SUBJECT: ISSUANCE OF AMENDMENTS - MCGUIRE NUCLEAR STATION, UNITS 1 AND 2, RADIATION MONITORING INSTRUMENTATION SURVEILLANCE INTERVAL (TAC NOS. M91475 AND M91476)

The Nuclear Regulatory Commission has issued the enclosed Amendment No. 154 to Facility Operating License NPF-9 and Amendment No. 136 to Facility Operating License NPF-17 for the McGuire Nuclear Station, Units 1 and 2. The amendments consist of changes to the Technical Specifications (TS) in response to your application dated January 18, 1995.

# TABLE 4.3-3

# RADIATION MONITORING INSTRUMENTATION FOR PLANT OPERATIONS SURVEILLANCE REQUIREMENTS

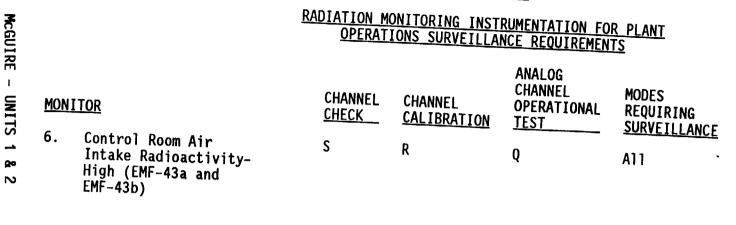
The amendments revise TS Table 4.3-3 to allow the analog channel operational test interval for radiation monitoring instrumentation to be increased from monthly to quarterly, and are consistent with the guidance in Generic Letter 93-05, "Line-Item Technical Specifications Improvements to Reduce Surveillance Requirements for Testing During Power Operation."

The licensee has proposed to change the analog channel operational test interval for the radiation monitoring instrumentation in TS Table 4.3-3 from monthly (M) to quarterly (Q). The NRC staff evaluated this issue as discussed in Section 5.14 of NUREG-1366, "Improvements to Technical Specification Surveillance Requirements," dated December 1992. The following discussion is based on the NUREG report and on the Generic Letter 93-05 that identified potential changes that licensees could propose to facility TS.

- UNITS 1 & 2	MON	MONITOR		CHANNEL CALIBRATION	ANALOG CHANNEL OPERATIONAL TEST	MODES REQUIRING
	1.	Containment Atmosphere Gaseous Radioactivity- High (Low Range-EMF-39)	S	R	Q	<u>SURVEILLANCE</u> 1, 2, 3, 4
	2.	Spent Fuel Pool Ventilation Radioactivity-High (EMF-42)	S	R	Q	**
3/4 3-43	3.	Criticality-High Radiation Level (Unit 1 - 1EMF-17 and Unit 2 - 2EMF-4)	S	R	Q	*
	4.	Gaseous Radioactivity- RCS Leakage Detection (Low Range-EMF-39)	S	R	Q	1, 2, 3, 4
Amendm	5.	Particulate Radioactivity- RCS Leakage Detection (Low Range-EMF-38)	S	R	Q	1, 2, 3, 4
